**GOVERNMENT OF THE DISTRICT OF COLUMBIA
DEPARTMENT OF TRANSPORTATION**

MEMORANDUM

SUBJECT: Zoning Commission Case No. 15-12 – 1401 Pennsylvania Ave SE

Figure 1 - Site Design and Access (Source: Gorove/Slade)

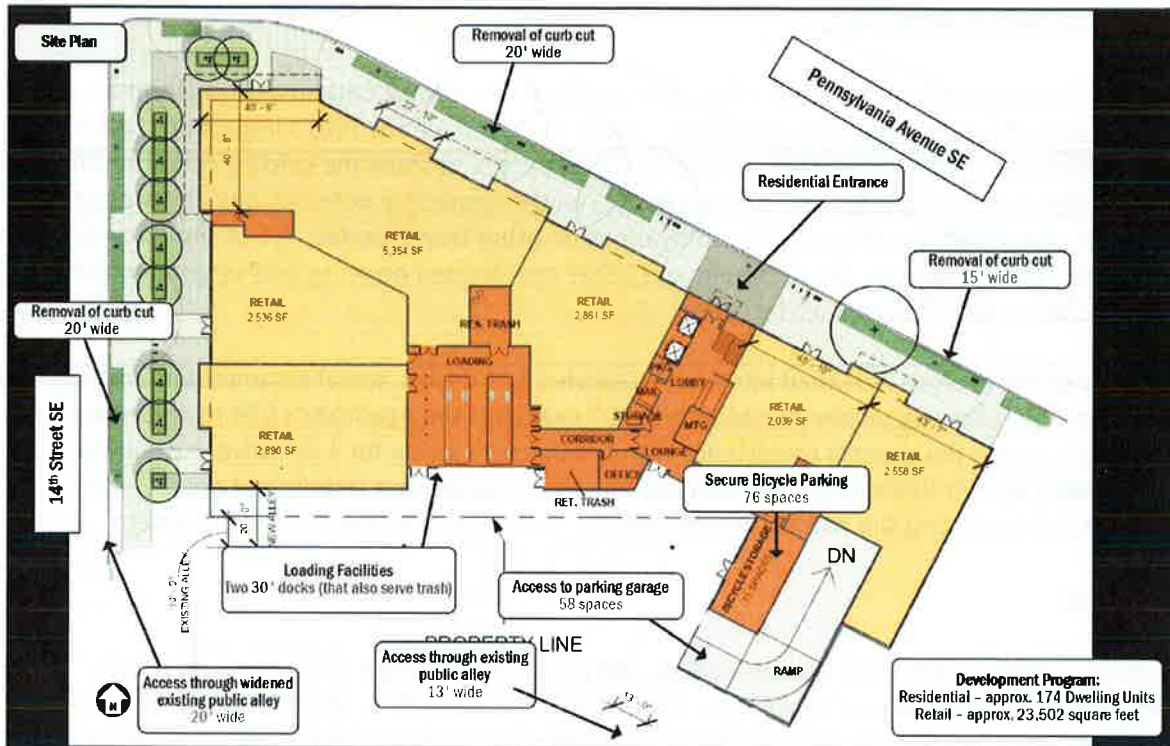
An initial site plan provided to DDOT (Figure 1) did not show a continuous corridor connecting the loading facilities with the retail bays at the east end of the site (Retail E and Retail F). The Applicant has provided updated plans (Figure 2) showing the creation of a loading corridor. This update will provide direct access to all retail bays and residential areas to the loading facilities.

Figure 3 Proposed Curbside Management Plan (Source: Gorove/Slade)

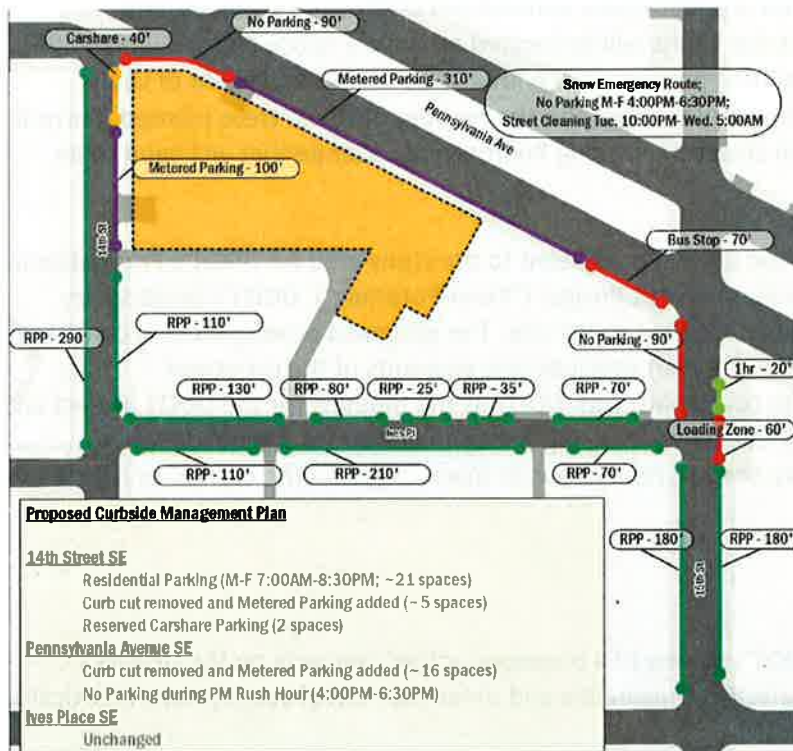
Under current conditions, curb cuts associated with the site on Pennsylvania Avenue and 14th Street limit the available curbside space for parking and other uses. The Applicant proposes to modify existing curbside uses as seen in Figure 3. The Applicant’s proposal would add approximately 20 metered parking spaces adjacent to the site. The proposal is generally consistent with DDOT’s expectation for curbside uses, but a final curbside management and signage plan, possibly including multi-space meter installation at the Applicant’s expense, consistent with current DDOT policies will be required during permitting.

Figure 7: Peak Hour Parking Occupancy (Source: Gorove/Slade)

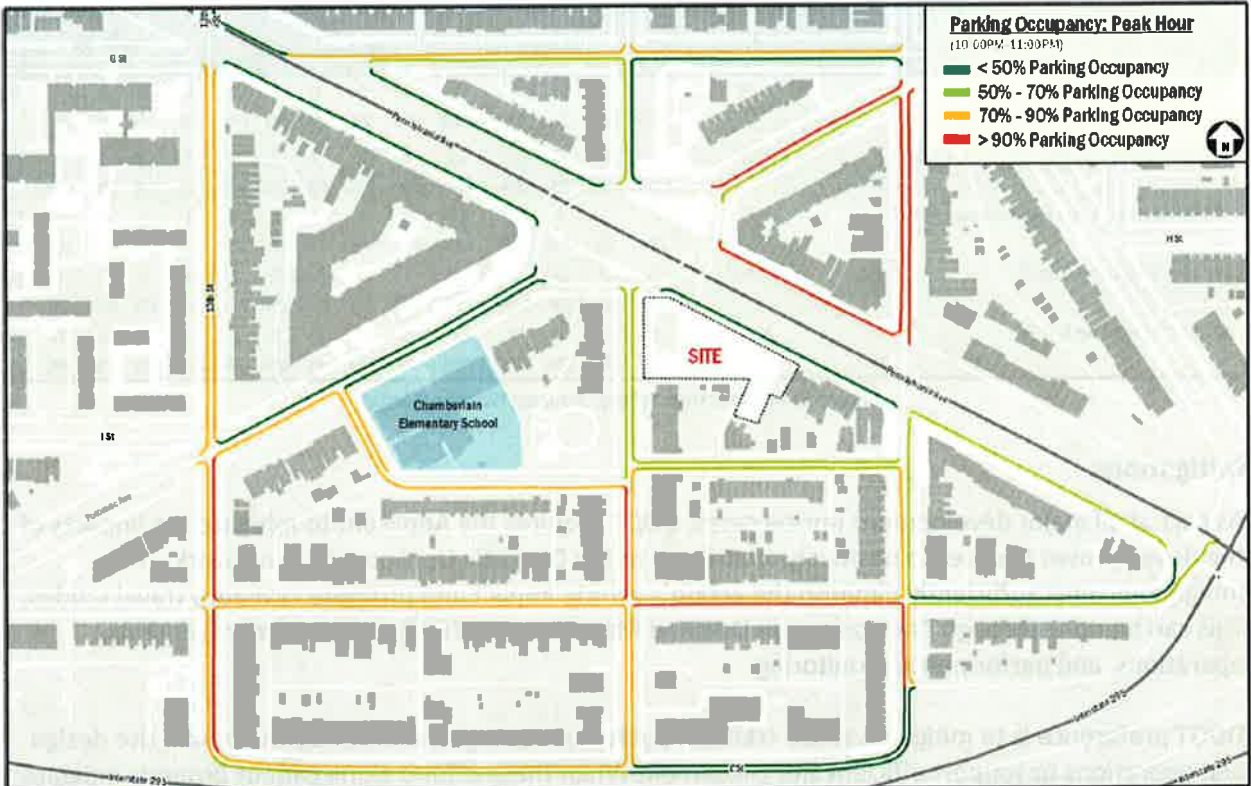
The Applicant surveyed parking utilization on a typical weekday during three time periods: afternoon (2:00pm-4:00pm), evening (4:00pm-7:00pm), and night (7:00pm-11:00pm). Occupancies for the overall study area in each time period are shown in Figure 6. The peak period for parking occupancy was found to be from 10:00-11:00pm as shown in Figure 7.

The Applicant’s parking occupancy inventory found that curbside parking availability in the vicinity is adequate to accommodate potential spillover parking from the action. The Applicant proposes a TDM plan, discussed in detail in the Mitigations section of this report, to encourage non-auto modes and reduce demand for parking by future residents, patrons, and employees.
